# Access Compliance Report

## Public Rights-of-Way

### (Curb Ramps)

Intersection ID: 15491	Main Street: FARM_POND_LN	Cross Street: WOODBEND_DR	Location: NE
ADA ID: ECEF9186B856	Ramp Type: PerpDiag	Initial Pass/Fail: Pass	Overall Compliance: No
		Severity Score: 12.5

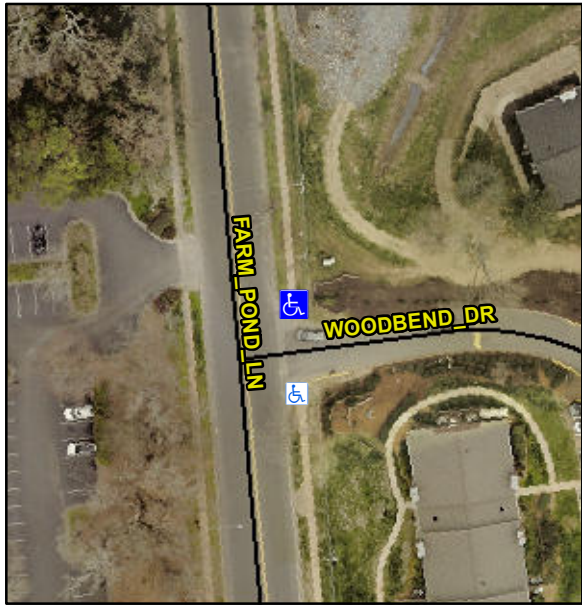
Codes/Mitigation Info/Possible Solution			Field Measurements/Component Compliance					
	Possible Solutions:		Compliance	Description	Data	Compliance	Description	Data
	Remove & Replace Curb Ramp With Two New Directional Ramps or Equivalent.		N/A	Ramp Length (in)	72.0	Yes	Ramp Slope (%)	7.6
			Yes	Ramp Width (in)	48.0	Yes	Ramp XSlope (%)	0.6
			N/A	Flare Type LT	Sloped	N/A	Flare Type RT	N/A
			N/A	Flare Slope LT (%)	4.6	N/A	Flare Slope RT (%)	4.5
			N/A	Flare Traversable LT?	Yes	N/A	Flare Traversable RT?	No
			No	Landing Length (in)	N/A	Yes	DWS Provided?	Yes
			No	Landing Width (in)	N/A	Yes	DWS Contrast?	Yes
			No	Landing Slope (%)	N/A	Yes	DWS Length (in)	24.0
			No	Landing X Slope (%)	N/A	No	DWS Full Width?	No
			N/A	Landing Curb? (Y/N)	No	No	DWS Offset (in)	3.0
			N/A	Shared Landing?	N/A			
			Yes	Gutter Ponding?	No	Yes	Gutter Slope (%)	1.2
			Yes	Gutter Lip Ht (in)	0.0	Yes	Gutter X Slope (%)	1.0
			N/A	Painted X Walk1?	No	N/A	Painted X Walk2?	No

X Walk 1 Direction	To W		X Walk 2 Direction	To S
			N/A	X Walk 1 Width (in)	N/A	N/A	X Walk 2 Width (in)	N/A
				X Walk 1 Slope (%)	0.5		X Walk 2 Slope (%)	1.4
				X Walk 1 X Slope (%)	0.2		X Walk 2 X Slope (%)	0.5
		N/A	Ramp inside XWalk1?	N/A	N/A	Ramp inside XWalk2?	N/A	
			Road Slope (%)	0.0	N/A	Clear Space?	Yes	
			Road X Slope (%)	1.6	N/A	Clear Space to XWalk (in)	N/A	
		Yes	Any Obstructions?	No	Yes	Storm Grate/Utility Hazard?	No	
			Obstruction Type			Storm Grate/Utility Type		
					N/A		N/A	
					Yes	Surface Condition? (G/P)	Good	
							</
